Westinghouse Response to Supplemental NRC RAIs on WCAP-17524, “AP1000 Core Reference Report” (Non-Proprietary)

March 2013

CRR-004-S1

Containment Pressure Response (2 inch Cold Leg Break) Initial vs. Final

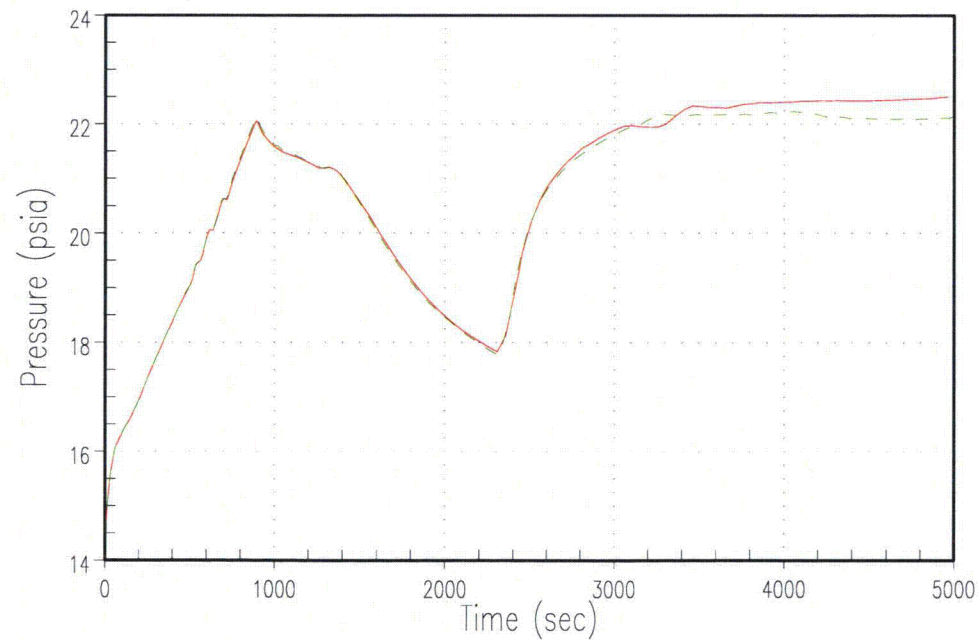
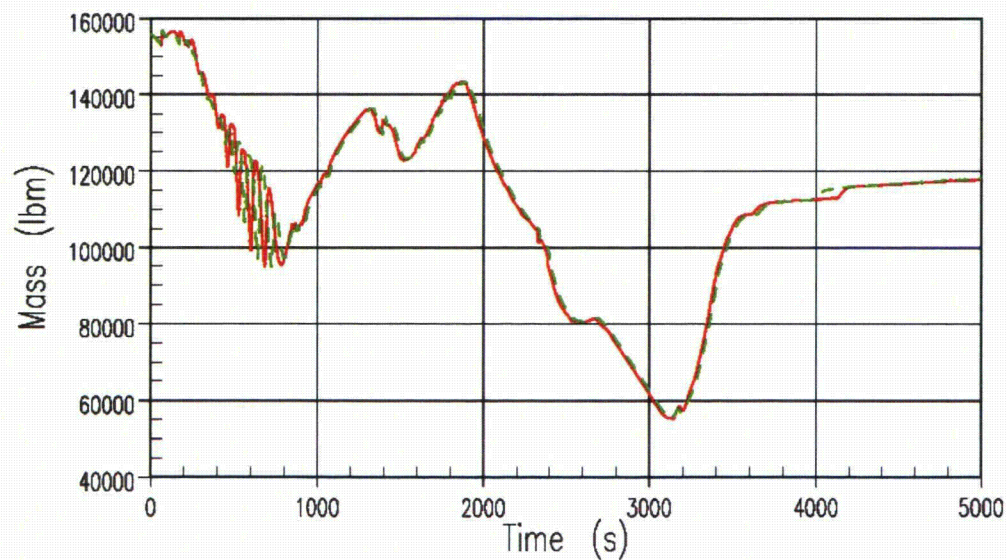
- Previous meeting held on 9/17/2013 at Westinghouse's Rockville office resulted in this question.
 1. Clarify starting with atmospheric pressure during its iterations of NOTRUMP (for mass and energy release) and GOTHIC (for containment pressure) and to justify their termination criteria. [This is because each iteration would be expected to result in a lower mass and energy release and consequently lower containment pressure.]

- Initial variable containment pressure response based on previous iteration of NOTRUMP variable containment simulation
 - A comparison between the M&E releases utilized for the generation of the variable containment pressure response and final NOTRUMP simulation was performed
 - No significant changes in simulation response and M&E releases observed
 - Negligible changes in containment pressure expected as a result if they were to be simulated with WGOTHIC
 - No additional iterations required

Inadvertent ADS Initial Temp Pressure Comparison

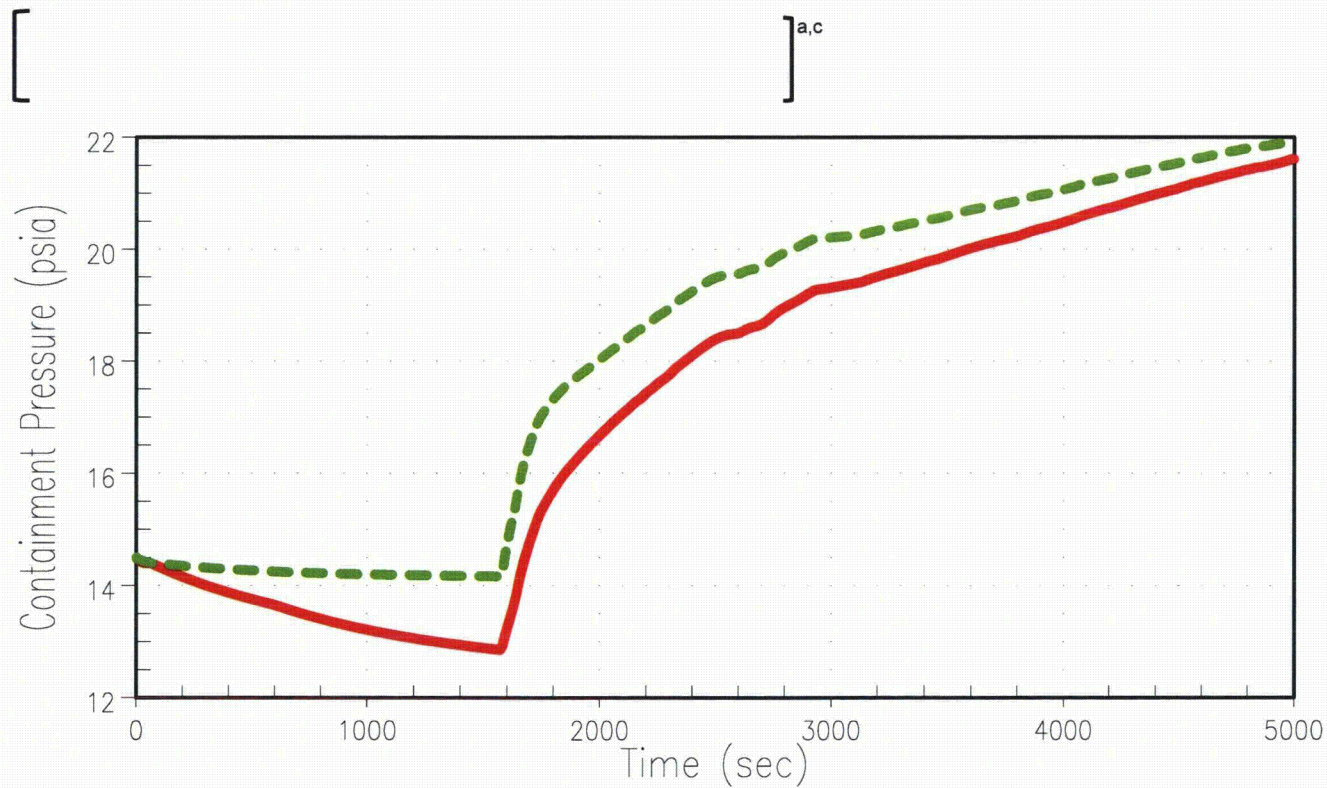
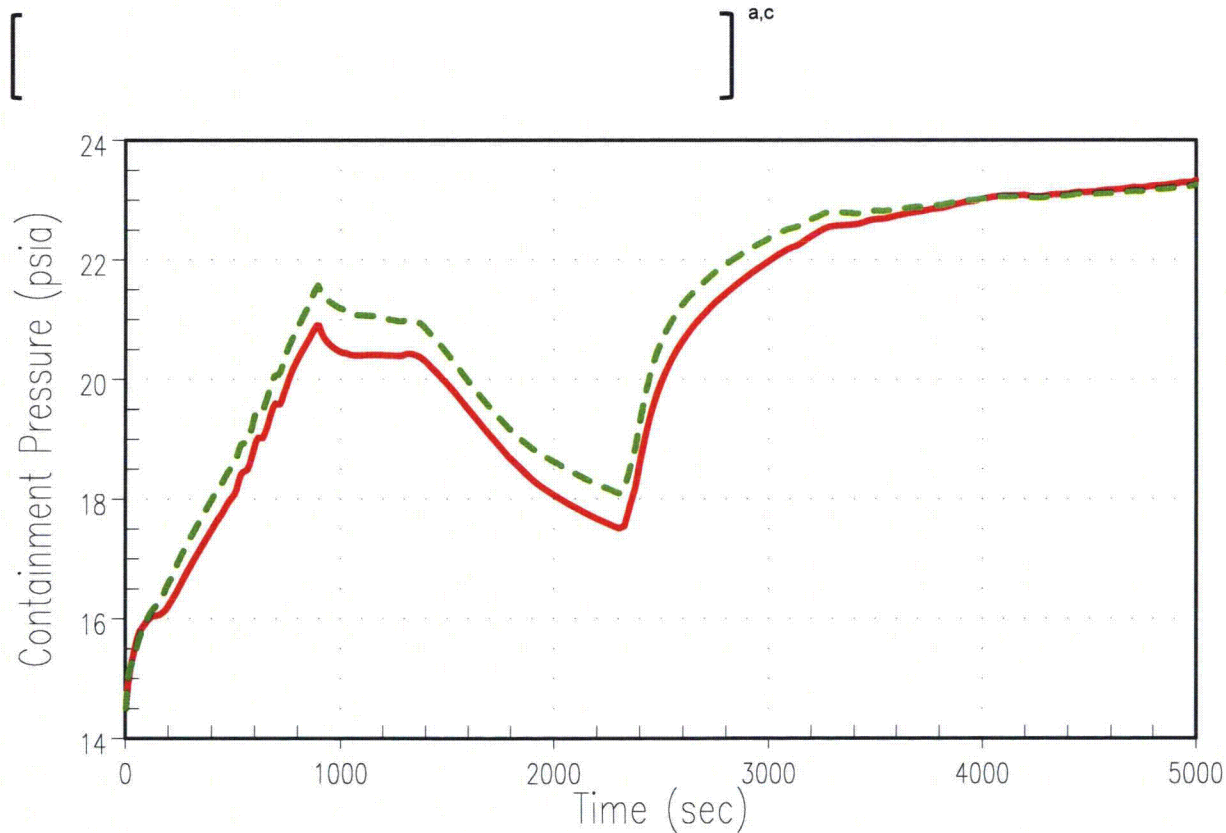
- NRC audit question...
“For Westinghouse to provide a justification for using []^{a,c} for the outside air temperature in the minimum containment pressure calculations.”
- The current SBLOCA minimum containment backpressure WGOTHIC analyses assumption of []^{a,c} as the outside initial air temperature is conservative
 - Analysis results are more sensitive to the initial inside air temperature and humidity (higher values are conservative)
 - Reduced outside air temperature requires reduced air temperature inside
 - **No** significant changes in alternate ADS-4 simulation response and M&E’s observed with small changes in containment pressure (iteration discussion)

- The containment pressure response is sensitive to the initial internal temperature and humidity
 - With higher initial containment temperature and humidity, more steam is able to condense on the containment shell and heat sinks, resulting in a lower transient pressure response
- The use of []^{a,c} as the initial outside air temperature is conservative compared to []^{a,c} for the following reasons:
 - At []^{a,c}, the maximum initial containment temperature is limited to []^{a,c} as opposed to 120°F
 - Once PCS is initiated []^{a,c}, the temperature difference through the containment shell is greater with a higher initial containment temperature
 - The fan coolers would remove more heat at the higher initial containment temperature
